**DRAFT SUPPLEMENTAL ENVIRONMENTAL IMPACT STATEMENT
FOR THE PROPOSED
CAMPO REGIONAL LANDFILL PROJECT**

COMMENTS

Victor M. Ponce

05 May 2010

Fig. 4 Proposed site groundwater flow direction map (click on figure to enlarge) (Campo Indian Reservation, 1992a).

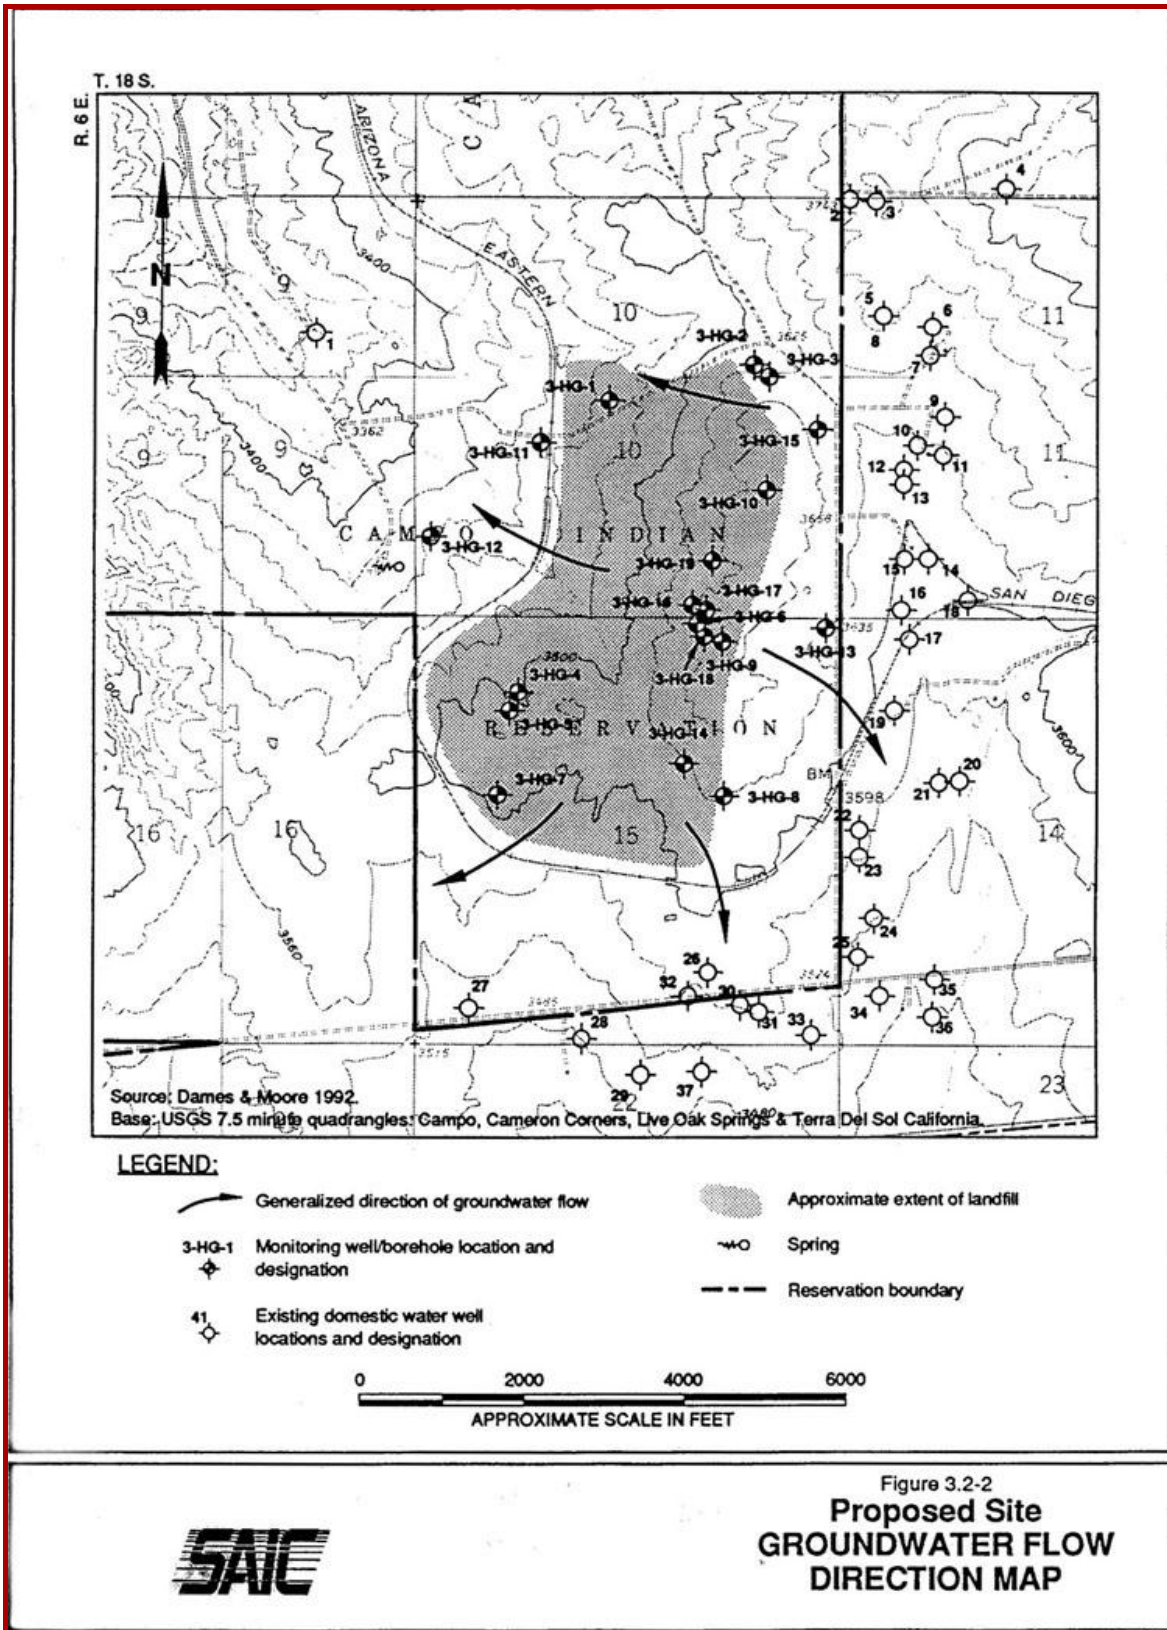
The existence of a connection in the regional groundwater flow below the landfill and its eastern neighbors is confirmed by a groundwater flow direction map prepared by the landfill consultants for the original EIS (Fig. 4) (Campo Indian Reservation, 1992a). This figure shows arrows also pointing east and south, indicating that groundwater may move east toward neighboring Tierra del Sol, and south toward Roca Magisterial, in Mexico.

Fig. 5 Proposed network of monitoring wells for phases 1-3 and 17-19 (click on figure to enlarge) (Bureau of Indian Affairs, 2010).

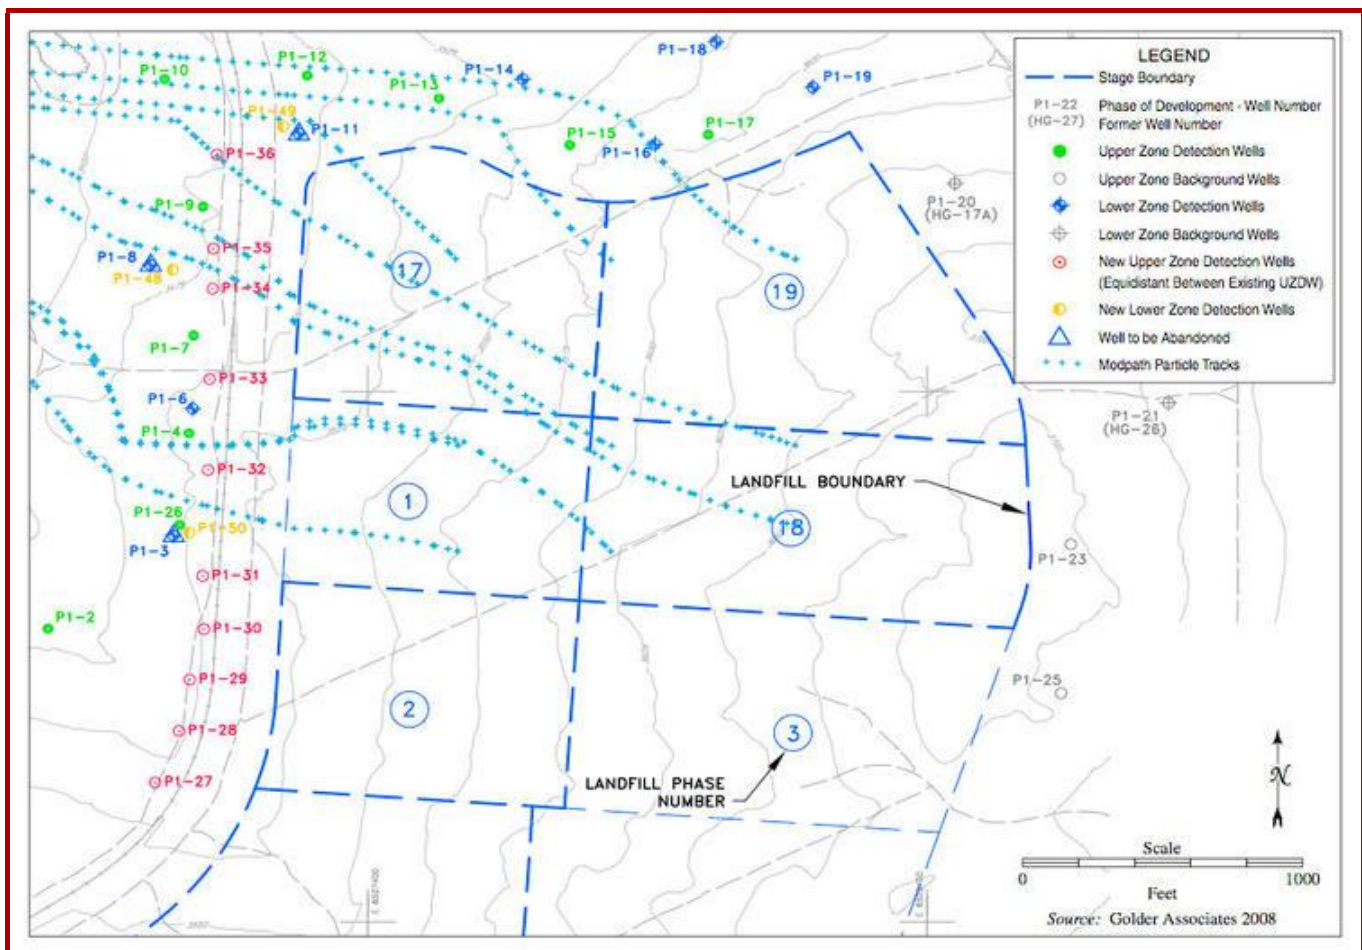
Figure 5 shows the network of monitoring wells proposed for phases 1-3 and 17-19 of the landfill project. The project plans to develop a similar network for other phases prior to their construction (Bureau of Indian Affairs, 2010). Figure 5 shows that the distance between wells varies between 200 feet on the west side of the landfill to approximately 500 feet on the east side. The total number of monitoring wells on the east side is four.

For the expected values of transverse dispersion, plume widths will be on the order of 100 feet (Bureau of Indian Affairs, 2010; Appendix C-4, p. 31). The DSEIS states that the expected spacing for monitoring wells should be on the order of the expected transverse dispersion of the plumes, i.e., 100 feet (Bureau of Indian Affairs, 2010; Appendix C-4, p. 31). Thus, the proposed number of monitoring wells along the east side is judged to be grossly insufficient. Contaminant plumes will most likely be missed by the scant number of wells on the east side.

The absence of a detailed plan for east-side well monitoring for nearly two-thirds of the landfill footprint is a serious omission of the DSEIS. As currently conceived, the plan is expected to provide monitoring wells at a distance of about 500 feet on the east side. This is insufficient, and a cause for grave concern.

Fig. 6 West-east photogeological lineaments on the Campo landfill site (click on figure to enlarge) (Bureau of Indian Affairs, 2010; Appendix C-4).

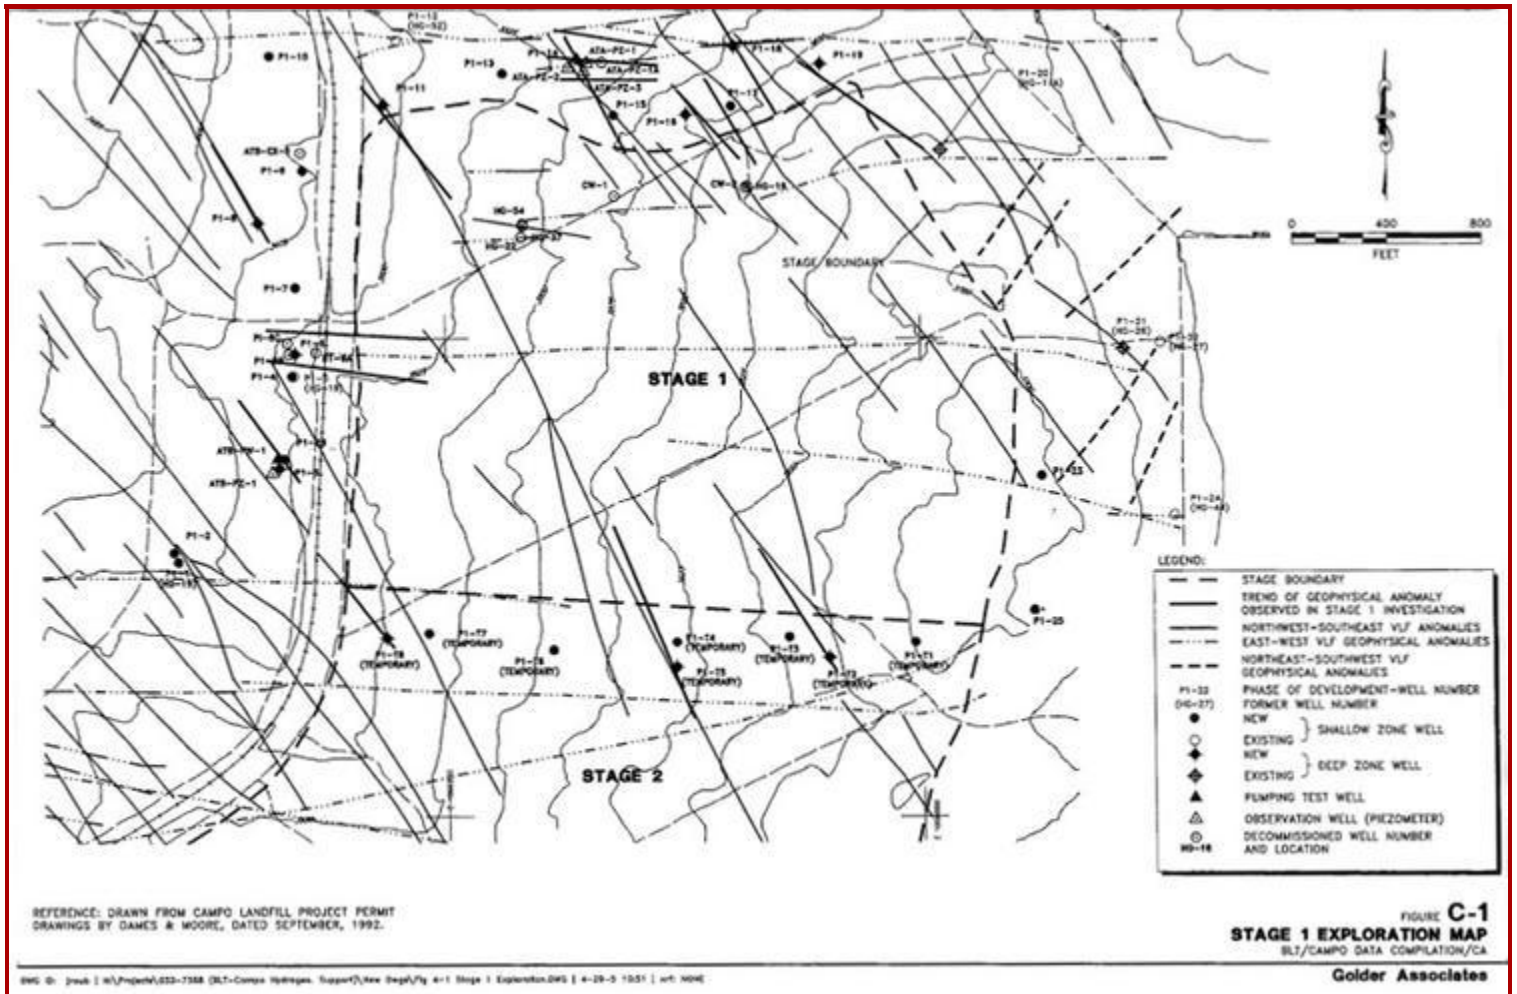
The DSEIS recognizes that there are several west-east lineaments crossing the Campo landfill site toward private lands along the east. These lineaments, shown in Fig. 6, were originally identified for the FEIS (Bureau of Indian Affairs, 2010; Appendix C-4: Appendix C, Figure C-1) (Campo Indian Reservation, 1992b). They have been confirmed by [Ponce \(2006\)](#) (Fig. 3).

The proven existence of these lineaments raises a significant concern that a landfill leak may reach private lands immediately east of the landfill. The DSEIS states that the most prominent fractures strike NNW, with moderate to shallow dips to the SW. Yet other fractures strike ENE to WNW, with moderate to steep dips to the N and S (Bureau of Indian Affairs, 2010; Appendix C-4, p. 12).

Fig. 13 Annual rainfall for the Campo weather station, 1901-2007 (click on figure to enlarge) (Bureau of Indian Affairs, 2010).

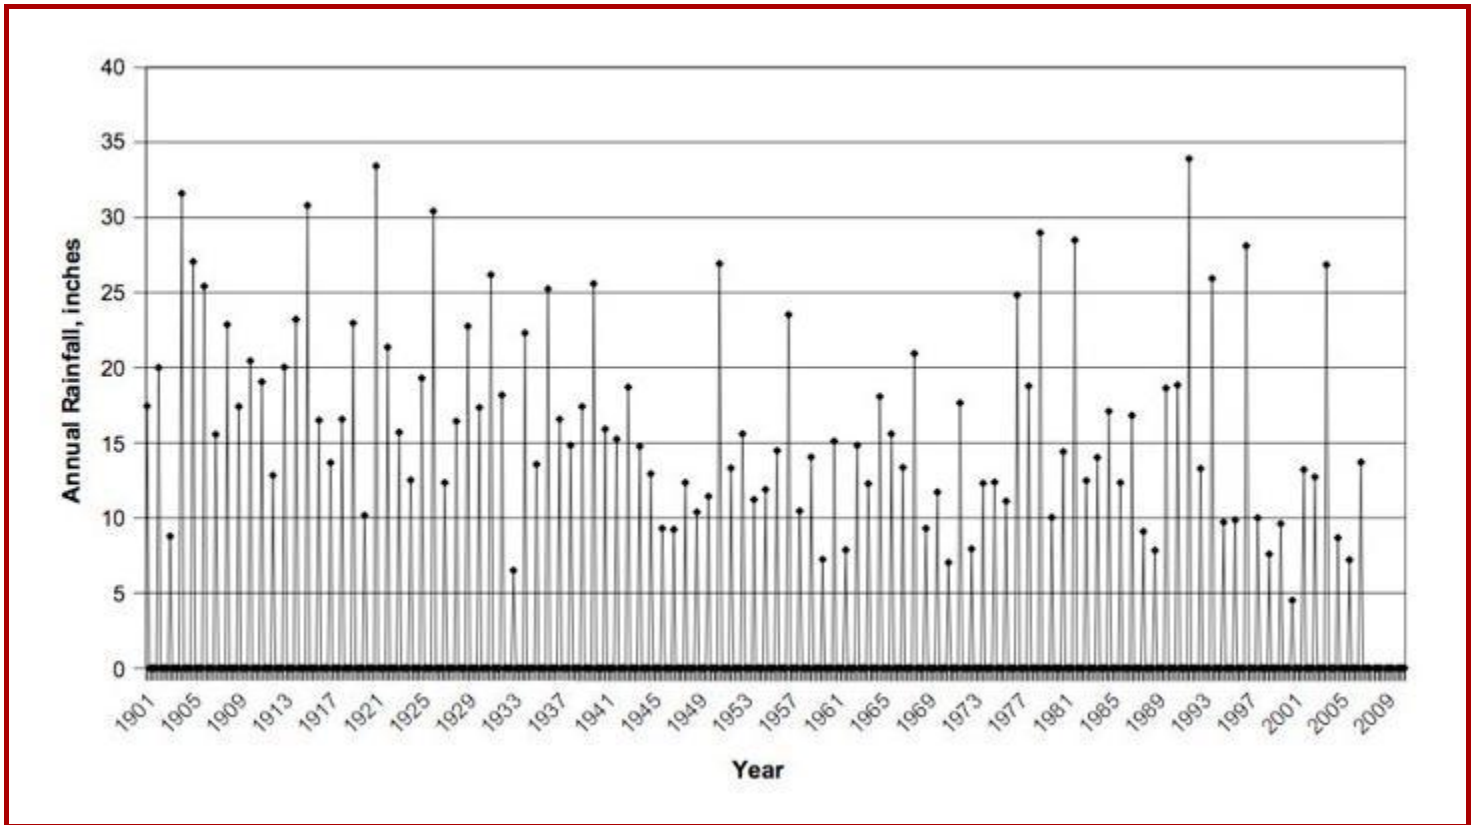
The DSEIS does include the precipitation data from the Campo weather station [in Campo, San Diego County] for the period 1901-2007, shown in Fig. 13. This figure depicts the high variability of annual rainfall in eastern San Diego County. Annual rainfall has exceeded 30 inches in five of the past 107 years, or once every 20 years; and 25 inches in sixteen of the past 107 years, or once every 7 years.

As shown in Fig. 13, the 1992-93 rainy season had the highest annual precipitation on record at the [National Weather Service] Campo weather station. Likewise, as shown in Fig. 14, the 1992-93 rainy season had the highest annual precipitation on record at the Morning Star Ranch raingage, located about 1,800 feet east of the proposed Campo landfill.

Fig. 19 County of San Diego disposal capacity projection 1995-2030
 (click on figure to enlarge) (County of San Diego, 2010).

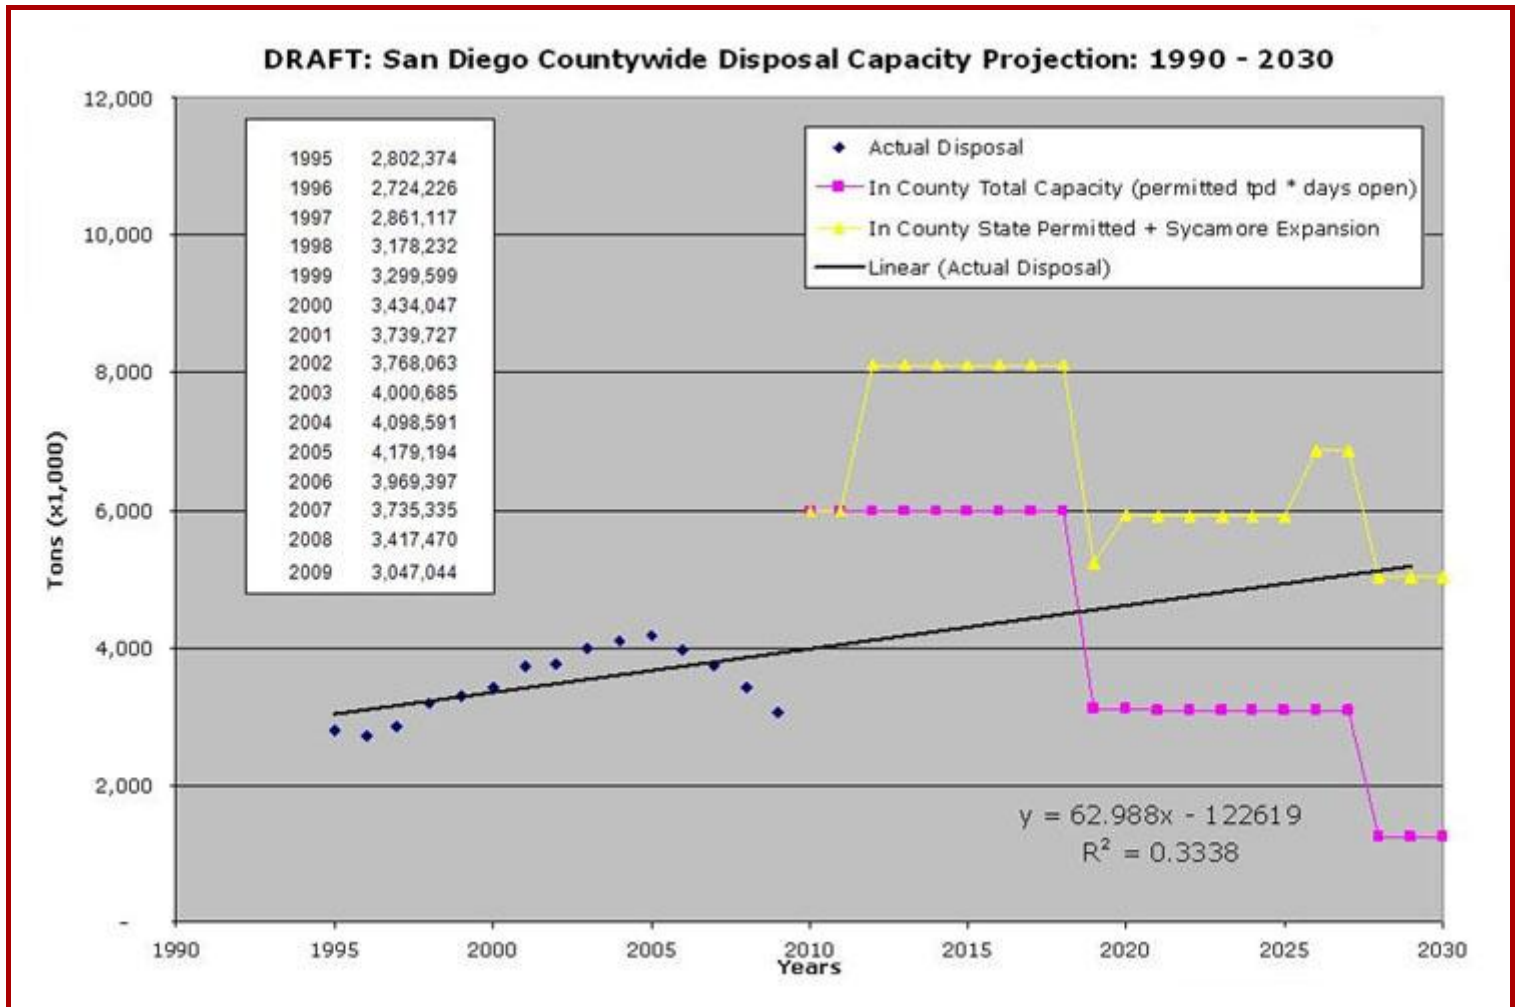
Figure 19 shows a sharp decrease in actual disposal tons, starting in 2005. This reflects both the economic downturn and the fact that in the past five years, San Diego County has been making great strides to comply with the state-mandated directive to: (1) reduce, (2) reuse, (3) recycle, and (4) transform, as a sustainable alternative to landfilling.

Fig. 20 Earthquakes (1800-2006) greater than Magnitude 4.5 and major faults within 93 miles (150 km) of the proposed Campo landfill (Bureau of Indian Affairs, 2010).

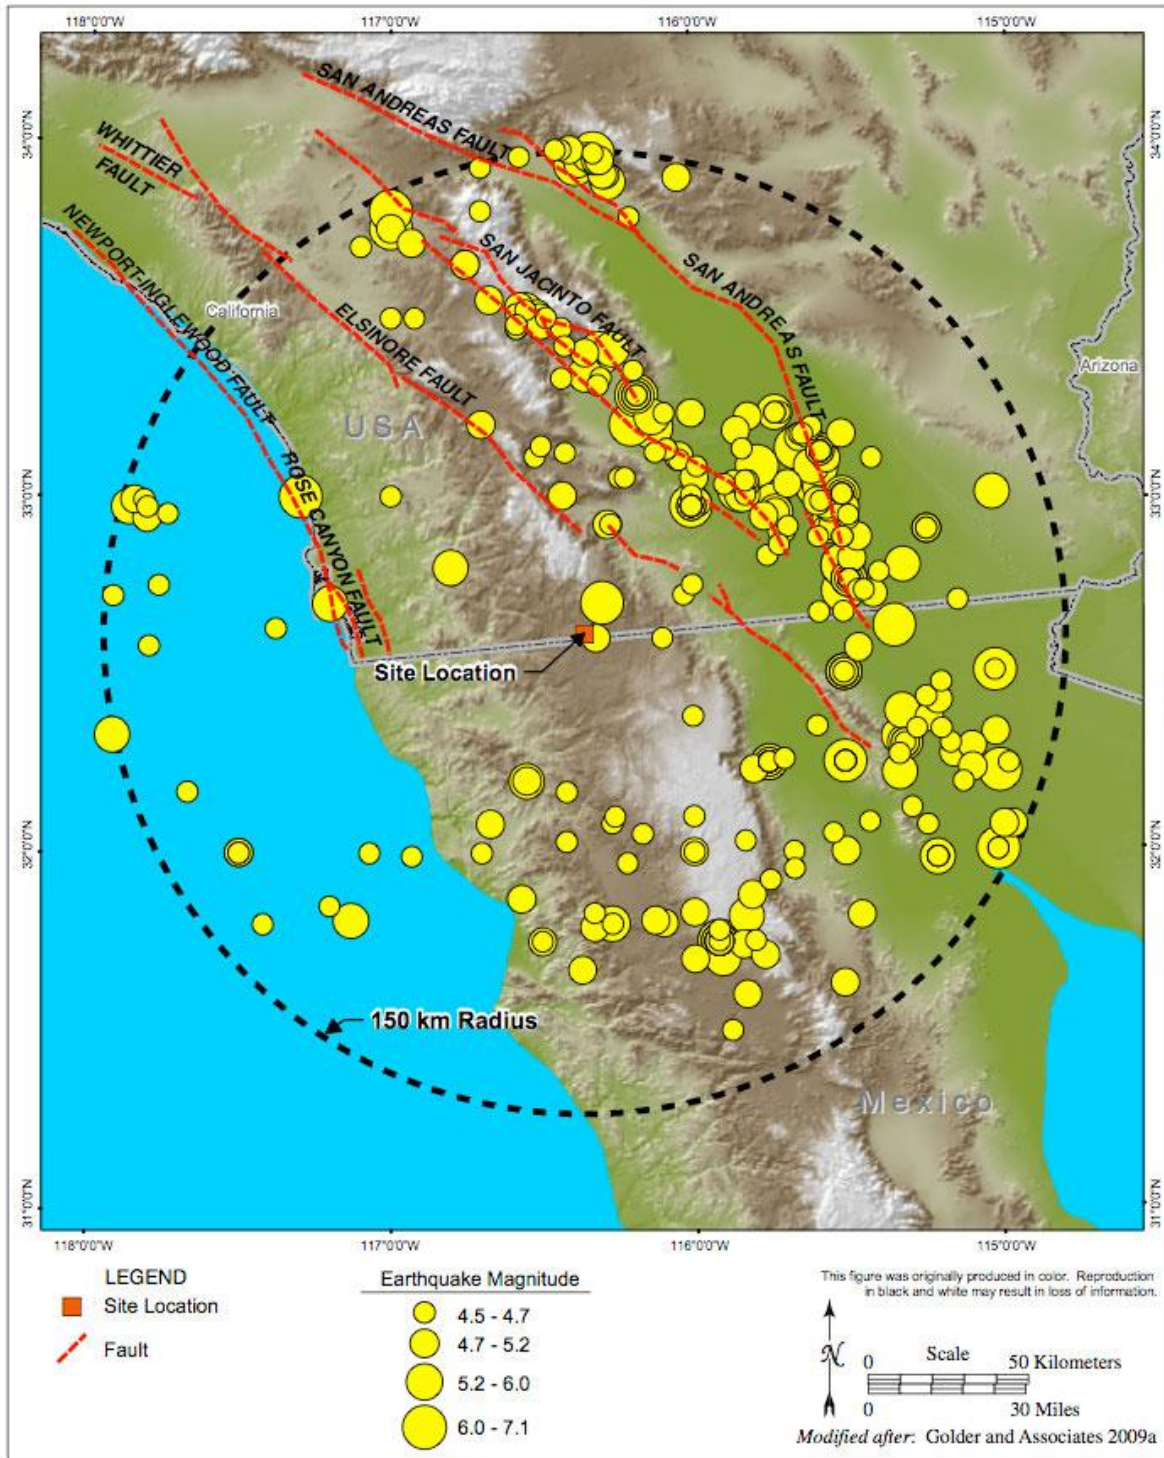
The DSEIS states that the largest historical earthquake was a Richter 7.1 event that occurred on November 11, 1915, with its center located 89 miles southeast of the project site (Bureau of Indian Affairs, 2010; p. 3.1-4). Yet according to the U.S. Geological Survey, the February 24, 1892 earthquake in the Imperial Valley, California, about 50 miles east of the project site, was of magnitude 7.8.²⁰

Note that Jewel valley, where ground fissures and rock slides were reported, is about 4 miles NE of the proposed landfill site, while Campo is about 4 miles WNW.²¹ Thus, the neglect of the February 24, 1892 earthquake, the largest on record, is a serious omission of the DSEIS.

The DSEIS states that the intensity of the Maximum Credible Earthquake (MCE) ranges from 6.0 to 7.4 on the Richter scale, depending on the originating fault (Bureau of Indian Affairs, 2010; p. 3.1-6). Apparently, the 7.8 magnitude earthquake was not considered in the development of the adopted 6.0-7.4 MCE range.
